Airport *Link*

Request for Project Change

MAY 2008

Queensland
Government

Figure 4-7
Kedron Park Worksite

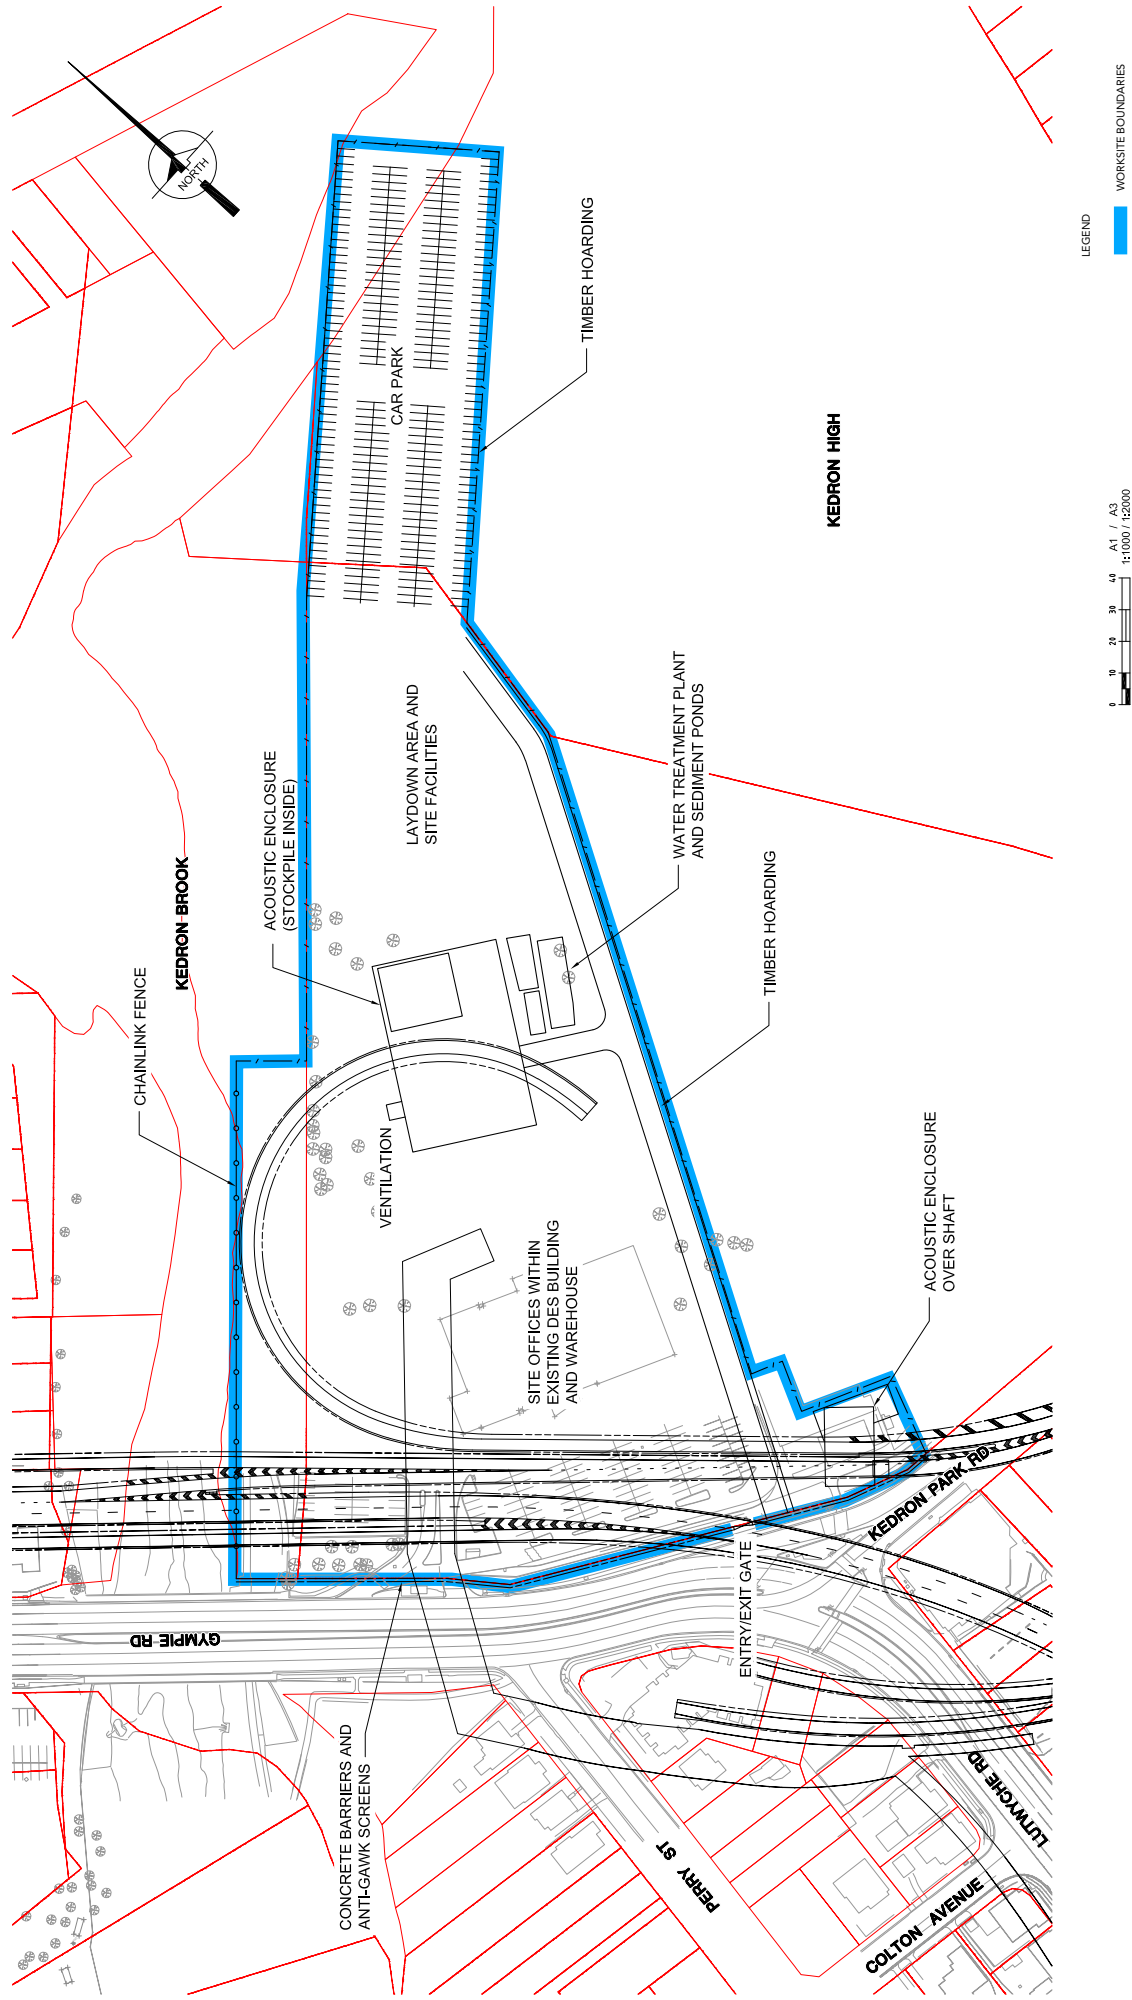
The construction requirements through the DES and Kedron Park High School areas at Kedron (refer **Figure 4-7**) would change significantly from the Reference Project. The Kedron worksite would be confined largely to the DES site. There would not be a worksite and associated tunnel workshop for the launching of the TBMs on the Kedron State High School land, as was required for the Reference Project.

The Kedron worksite at DES would extend along the southern bank of Kedron Brook to allow construction of the connection to the east-west tunnel. The worksite would also increase in area to the south to allow construction of a shaft to gain early access to the driven tunnels and associated ramps. An acoustic enclosure would be provided over this Kedron shaft and would include the spoil stockpile and handling facility to the north of the DES building.

Figure 4-8
Stafford Interchange Worksite and Gympie Road Worksite

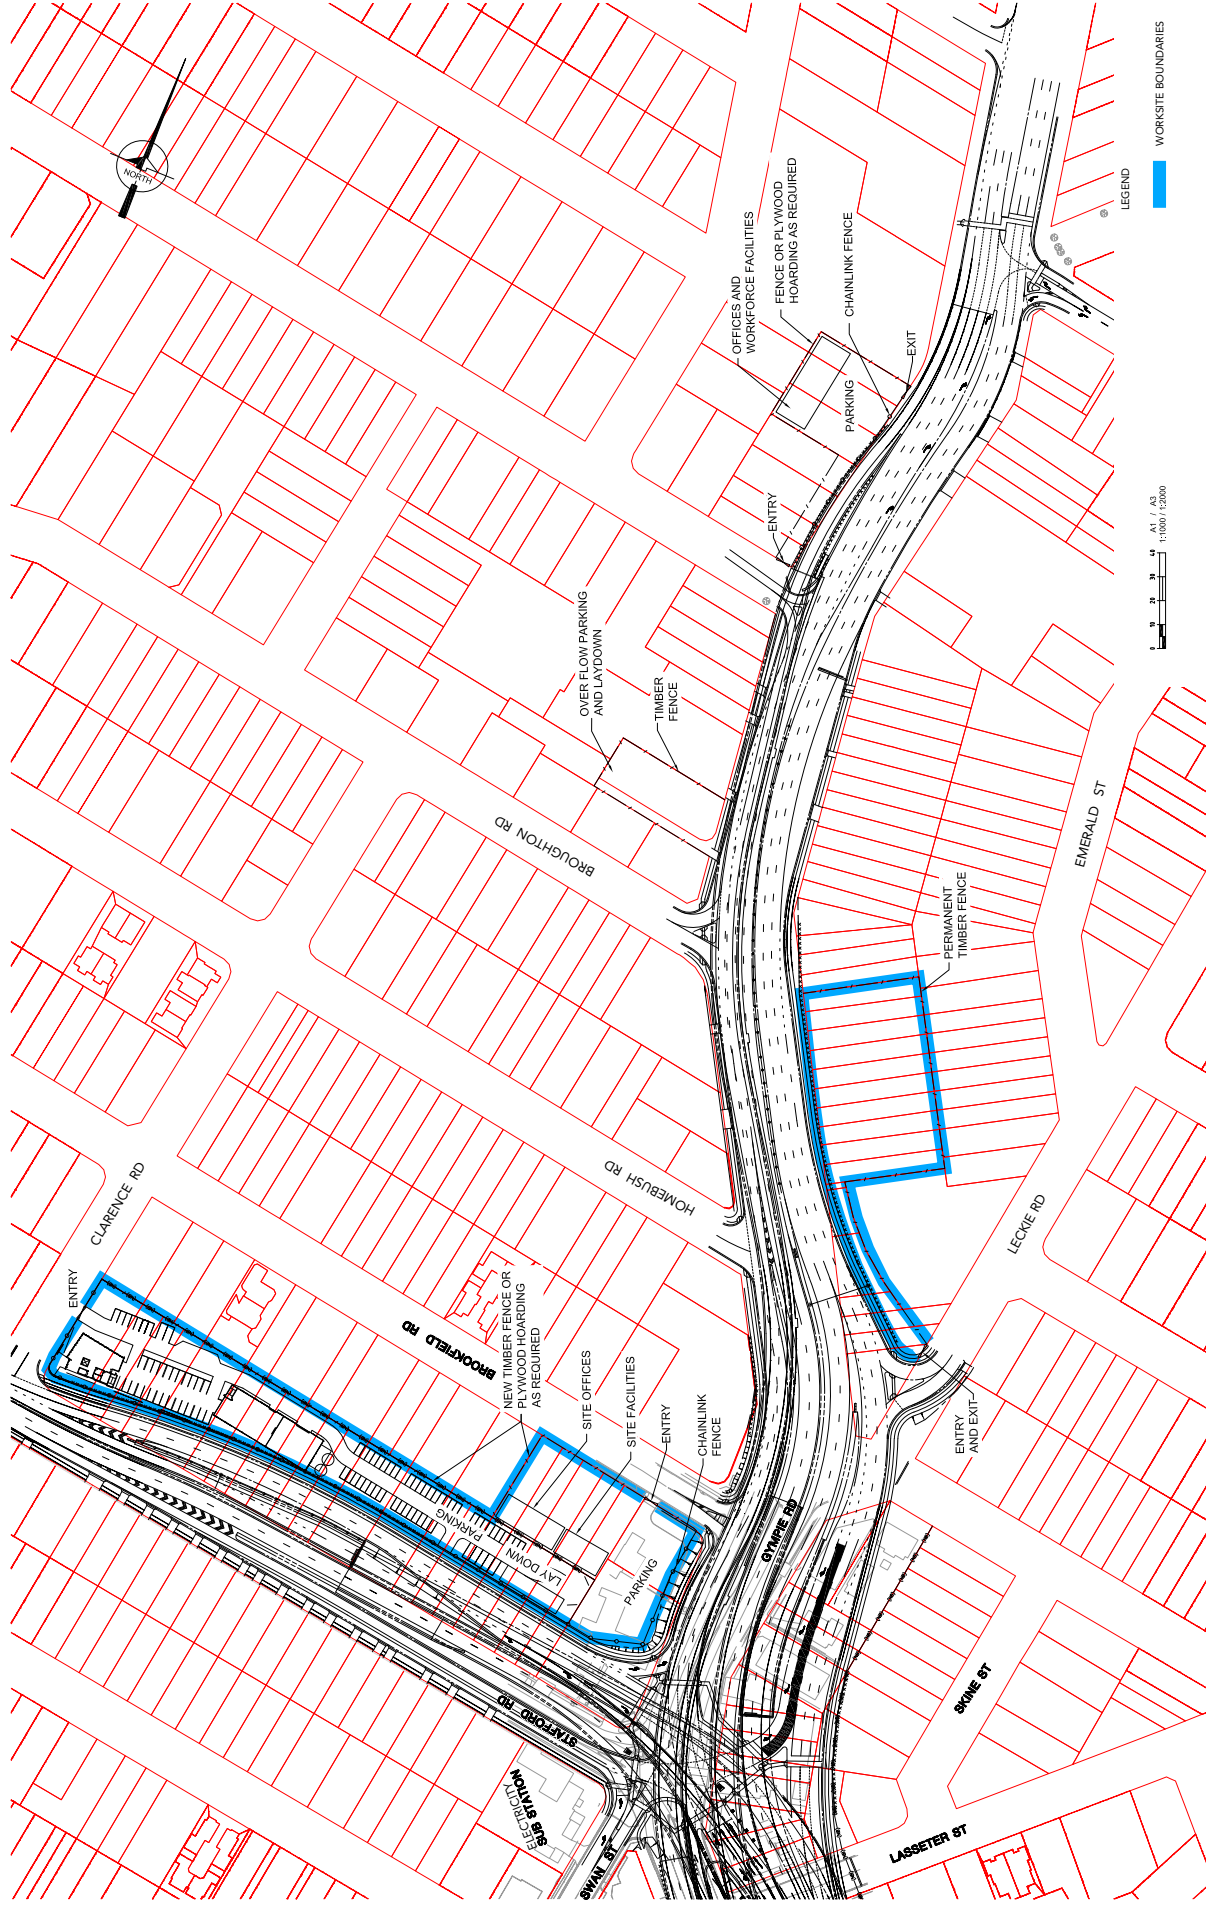
The Changed Project would include a new worksite located on the northern side of the Gympie and Stafford Road intersection, between Stafford Road and Brookfield Road (**Figure 4-8**). The site would provide access to the Stafford and Gympie Road interchange civil works. Spoil haulage from this cut and cover would exit onto Gympie Road to the northern haulage route. The worksite also would provide access for spoil haulage from the proposed transition trough located in the middle of Gympie Road. Access to this new worksite would from arterial roads.

Figure 4-9
Clayfield / Kalinga Park Worksite

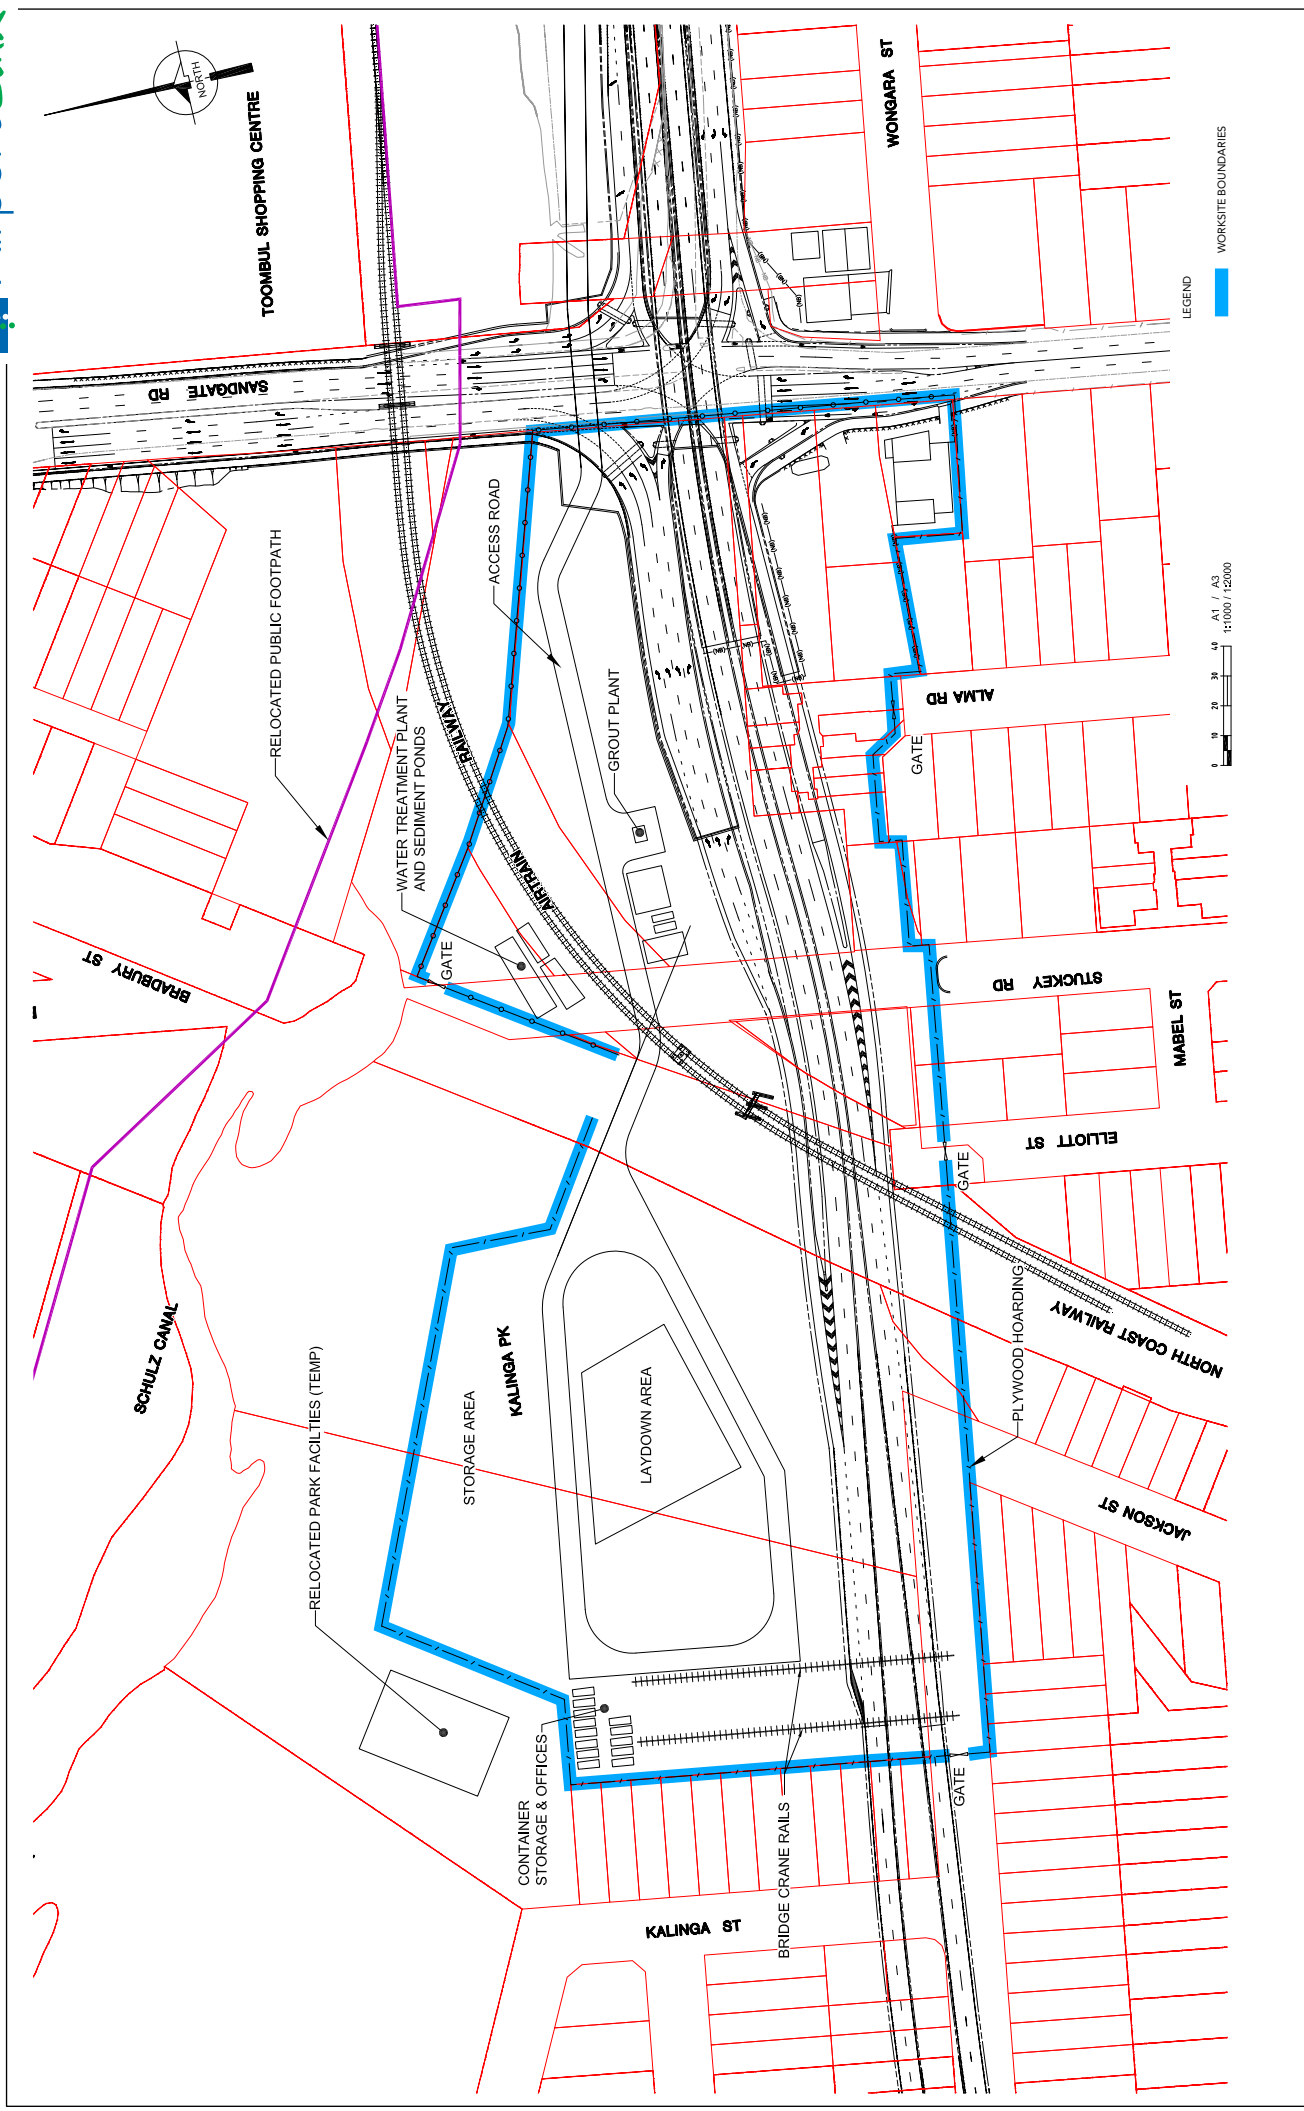
The Clayfield worksite within Kalinga Park (**Figure 4-9**) would increase in size from the Reference Project to accommodate the launching of the two TBMs. The enlarged worksite in Kalinga Park would extend to the property boundaries along the full length of Kalinga Street. The worksite would then extend from the northern end of Kalinga Street generally eastwards to the northern abutment of the North Coast Railway,

Figure 4-11
Truro Street Worksite

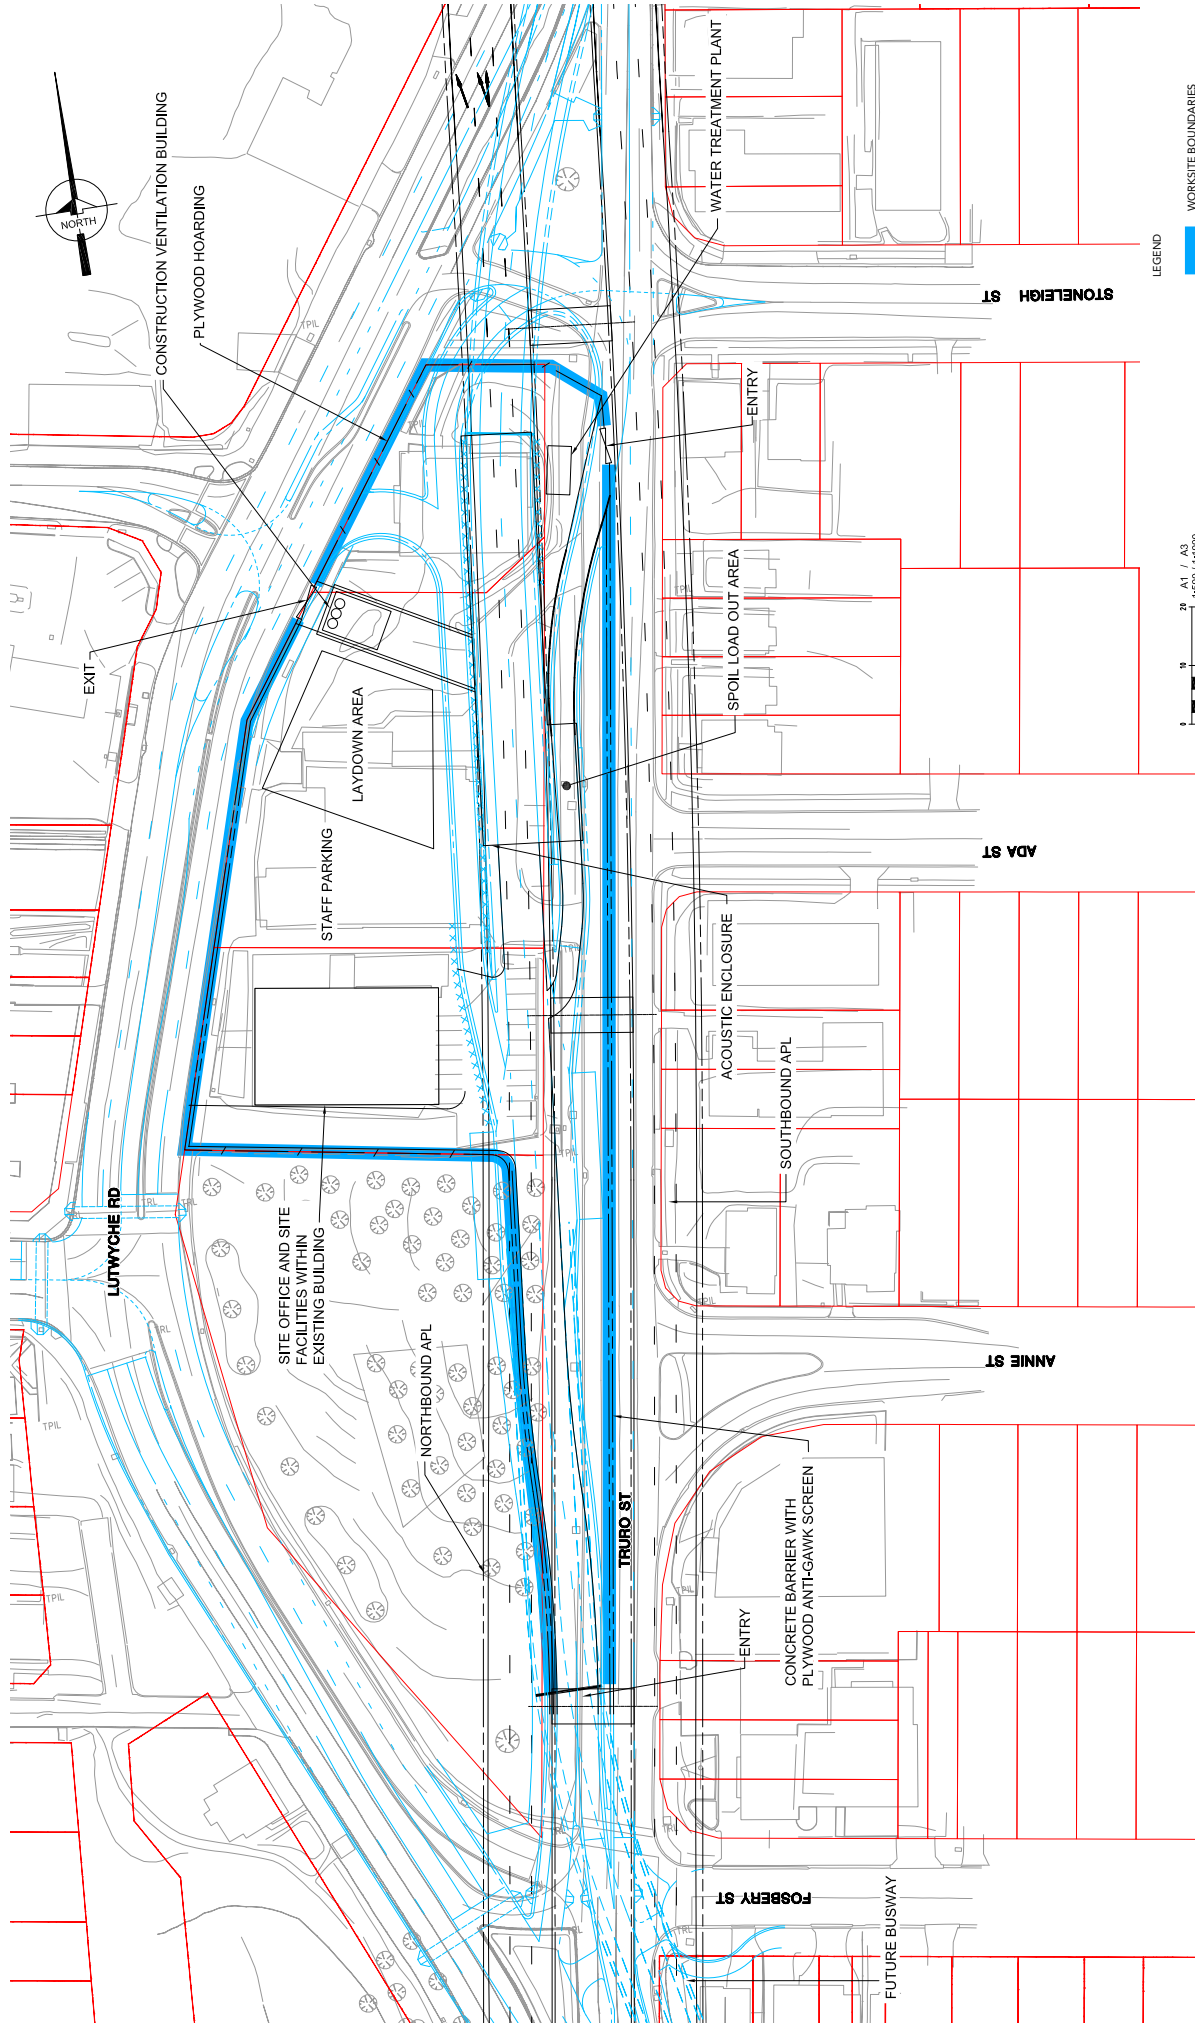
Mid-tunnel access for construction works for the Changed Project would be provided at the Northern Busway worksite (**Figure 4-11**) at Truro Street. Construction works for the Changed Project would utilise this worksite to gain access to the north-south tunnels of Airport Link, and would provide a single site for spoil handling and haulage for both projects.
